Addendum #2

Lewiston Armory Unheated Storage Building Project, Lewiston, Maine Project No. 23SC20-313-D, Bid Number #22-026

Directorate of Facilities Engineering

17 June 2022

SHEET ID:
ES101
 SHEET: 31 of 32

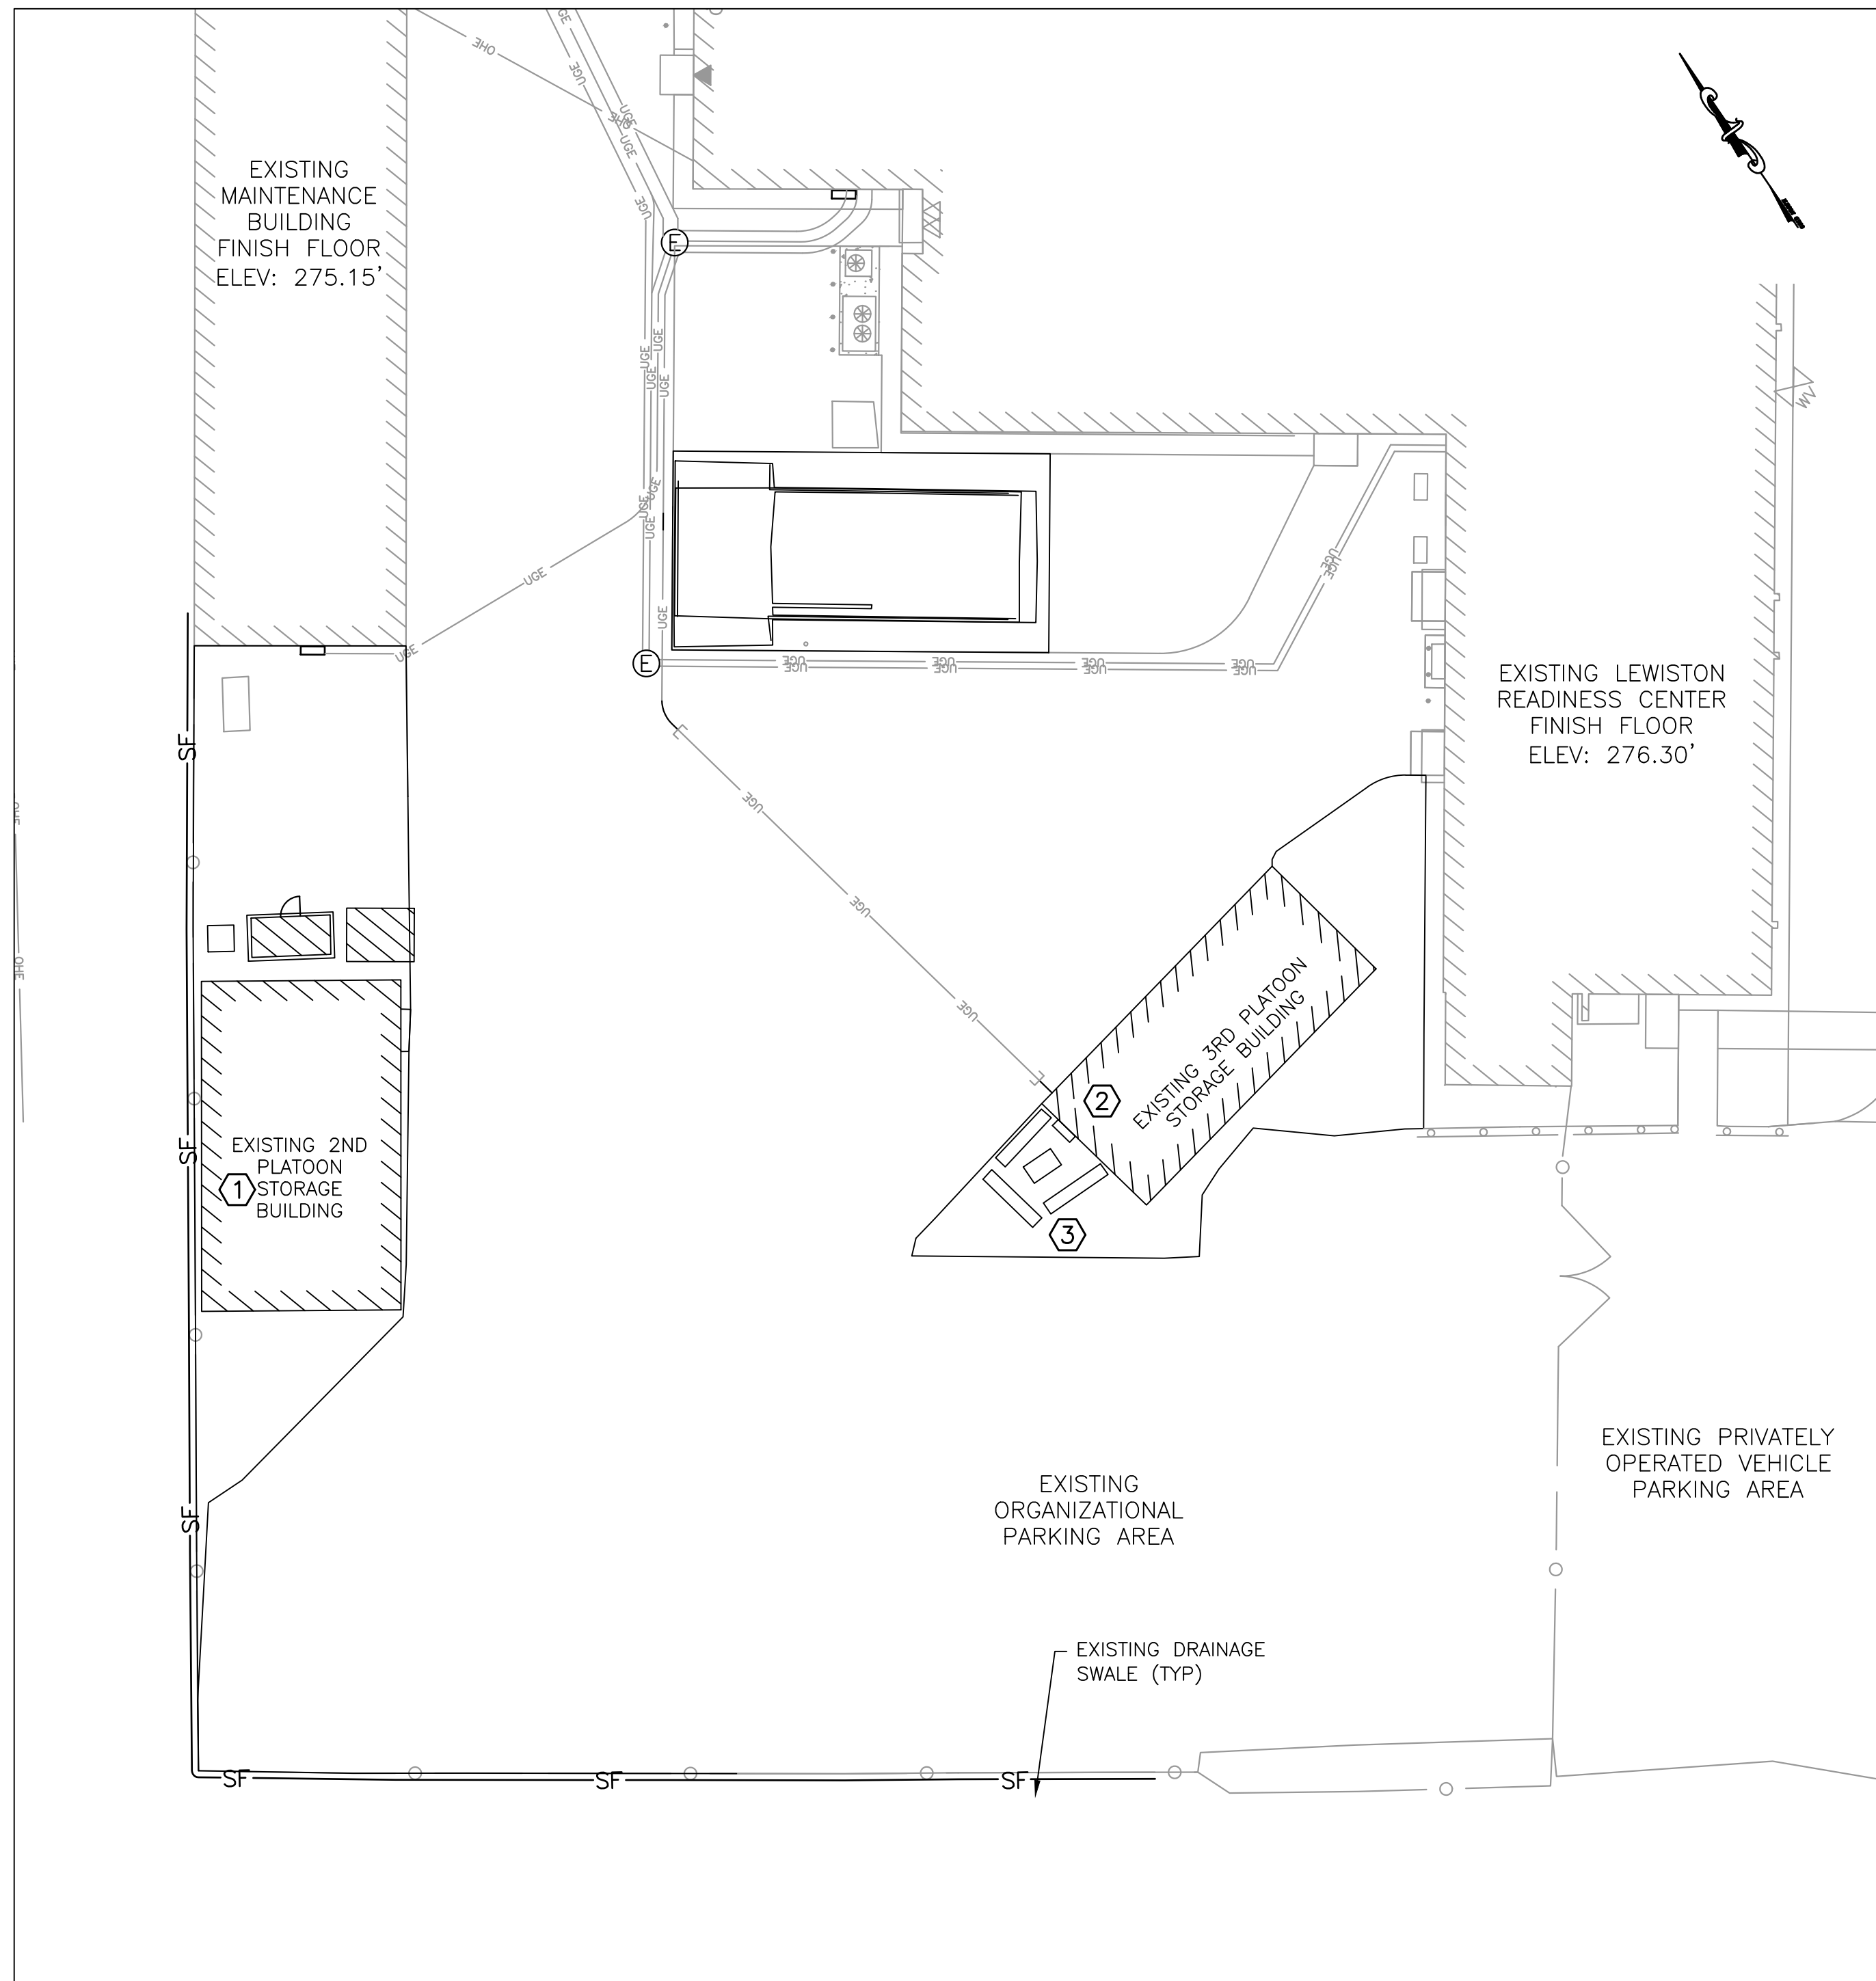
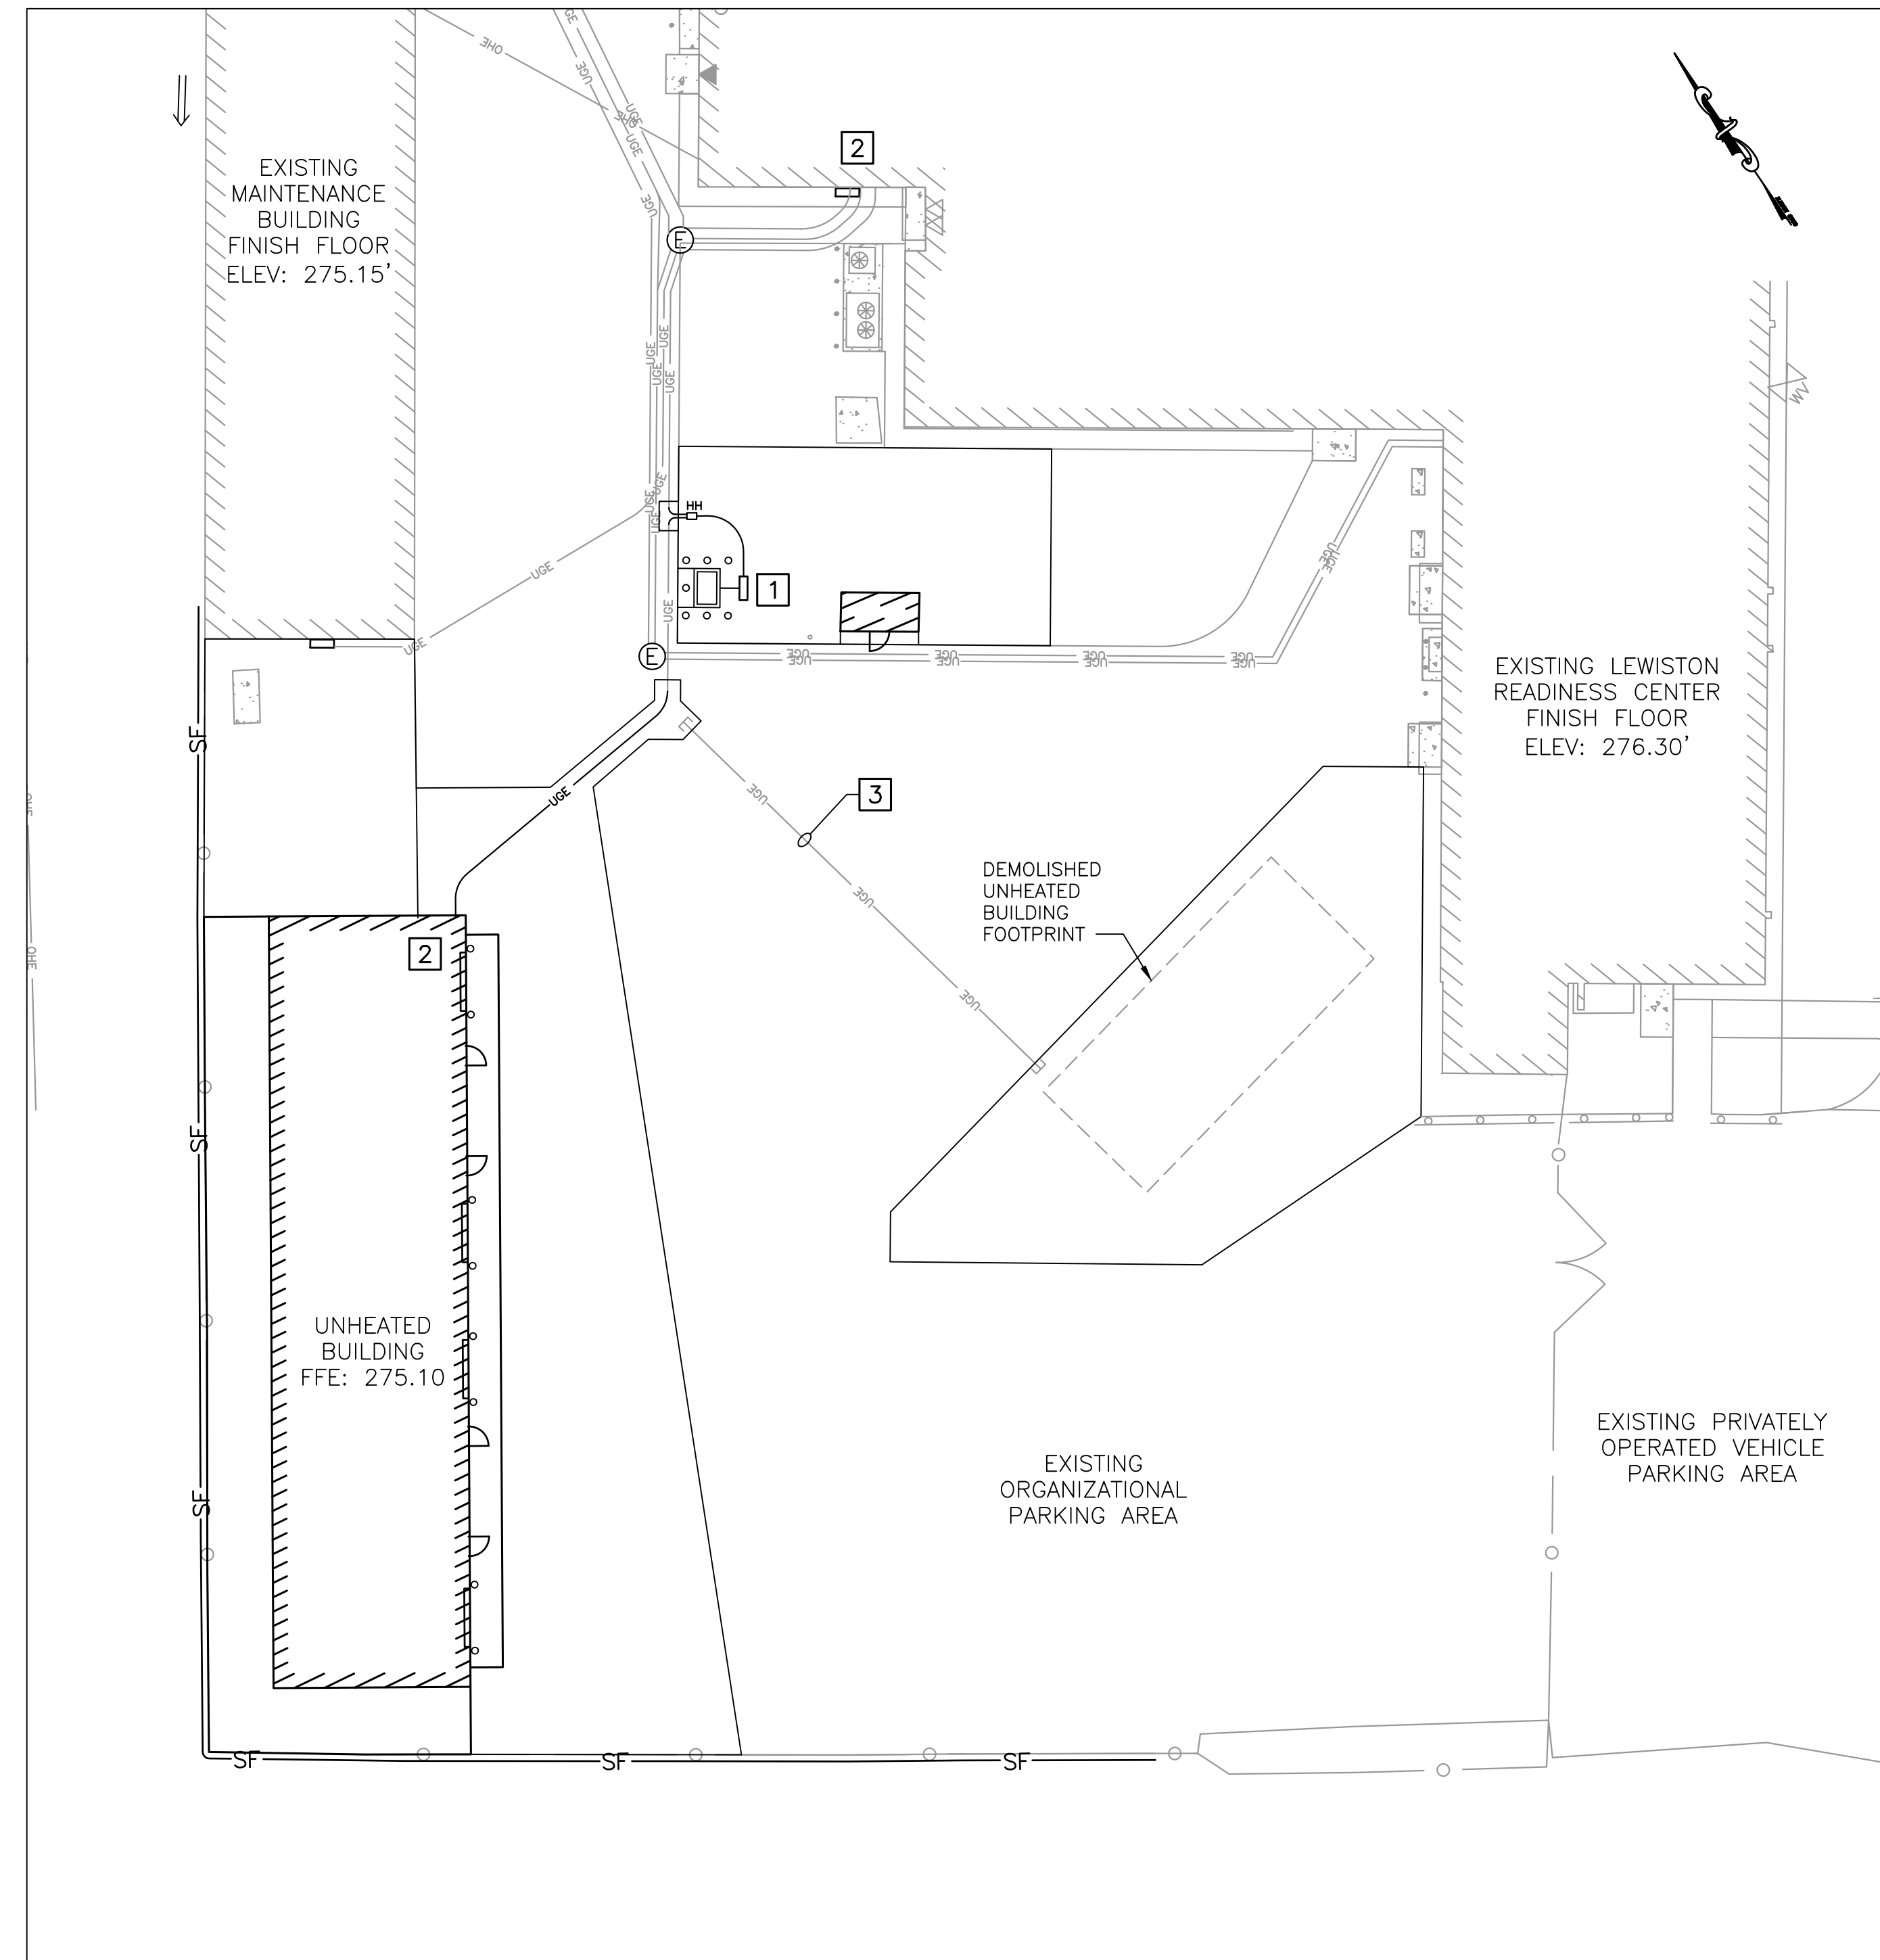
4. Q: Plan ES101 shows adding a handhole for the fuel station and connecting to the existing UG conduit. You don't show this as a separate conduit going back to panel GP in the new building. It shows one 2" conduit that I am assuming is for the panel feed and not the fueling station feed. Please provide direction on this.
A: The 2" conduit running between the handhole and the proposed building will contain feeds for both the proposed building and the fuel tank, which will be fed from the panel in the new building.

SHEET ID:
 E-101
 SHEET: 32 OF 32

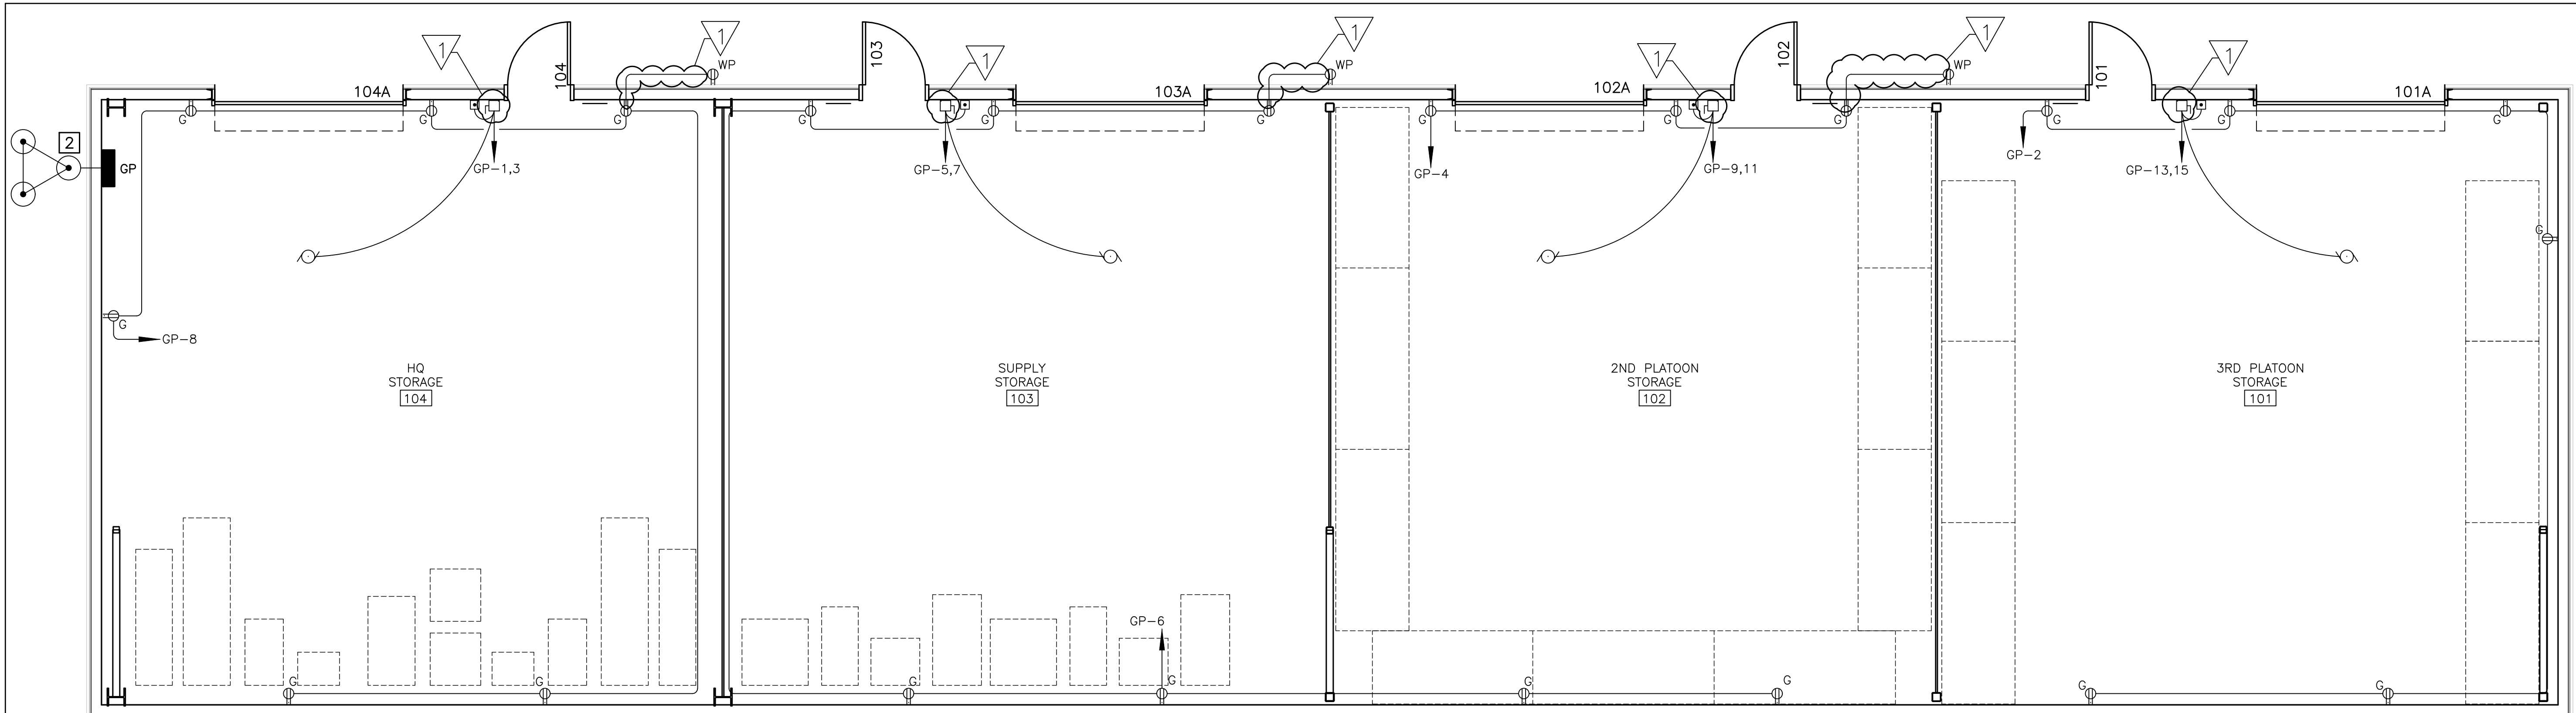
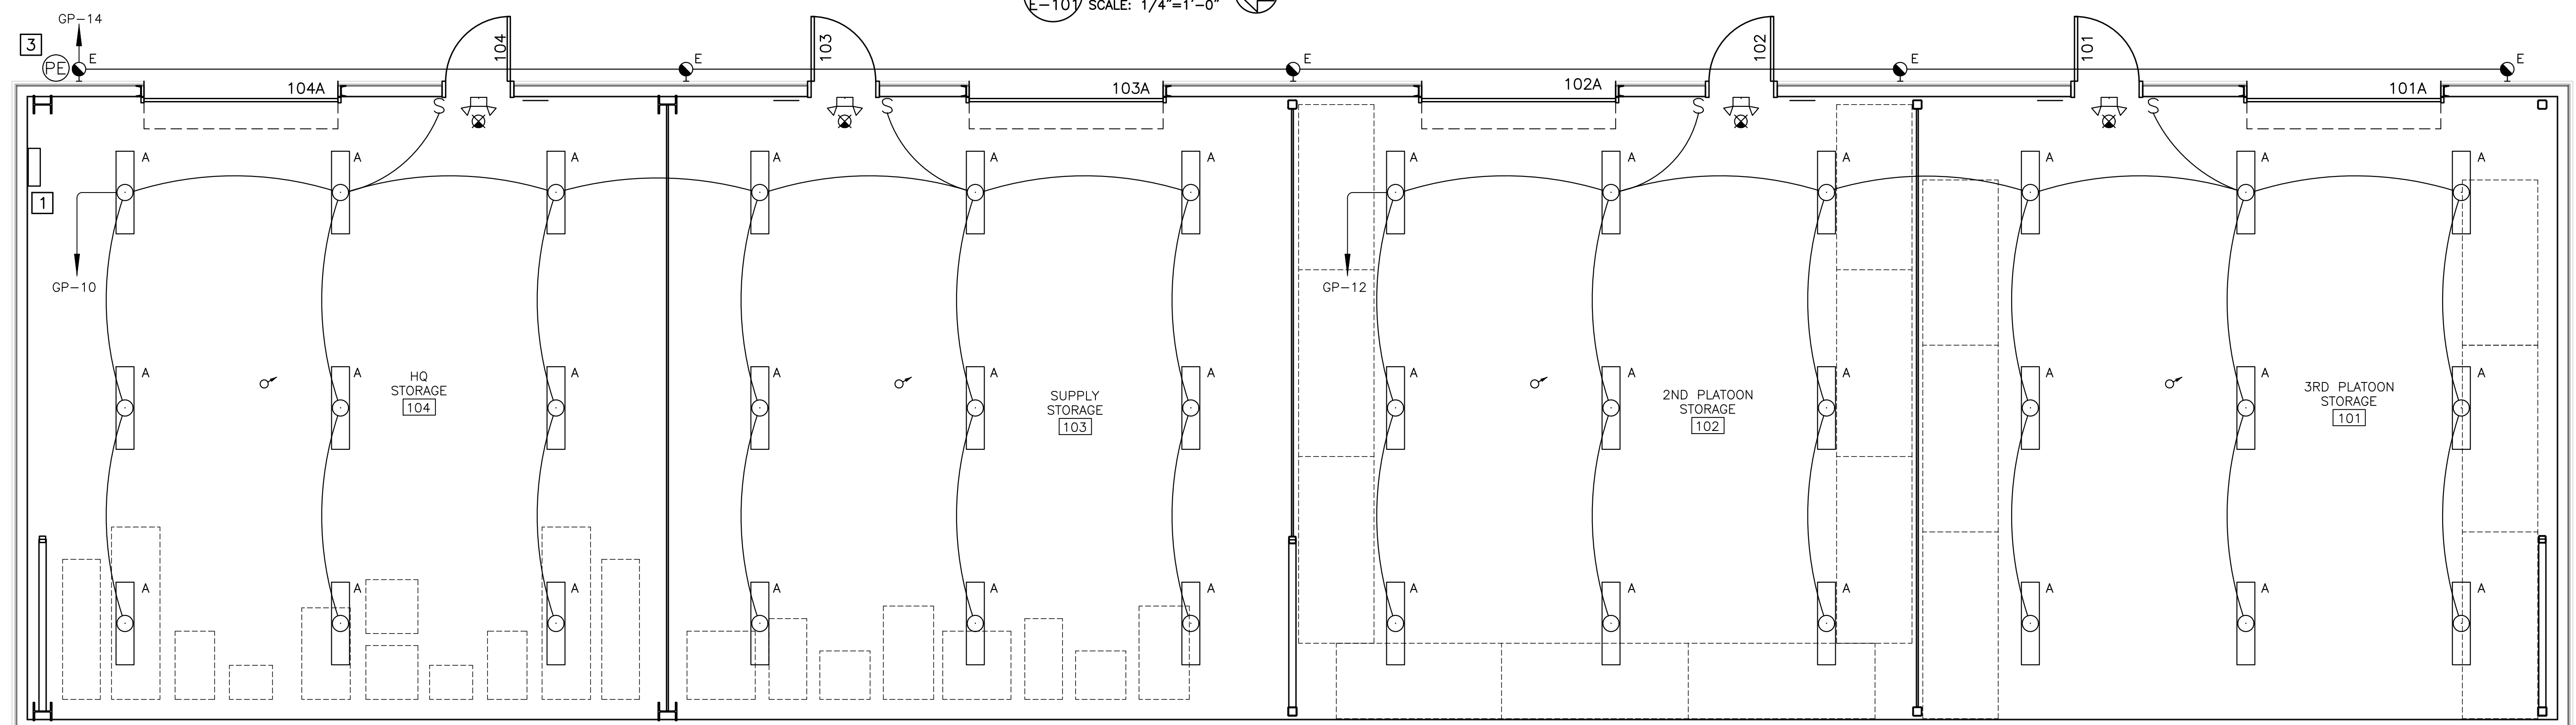
8. Q: Plan E-101 Conduit marking schedule – Will color conduit be excepted and eliminate color banding?

10. Q: Plan E-101 is showing fused disconnect switch for the overhead garage doors. Why does this need to be fused? Can we use a rated two pole toggle switch for the means of disconnect?

11. Q: Keynote 2 – Mount remote inverter for exterior fixtures. Can you provide a spec or an equal to model for the inverter you're looking for?

A: Banding must be used on surface-mounted conduit.

A: An HP-rated, lockable toggle switch is acceptable.

A: Lightgear 125W or approved equal sized for connected load, per sheet E-001 fixture schedule note 2.
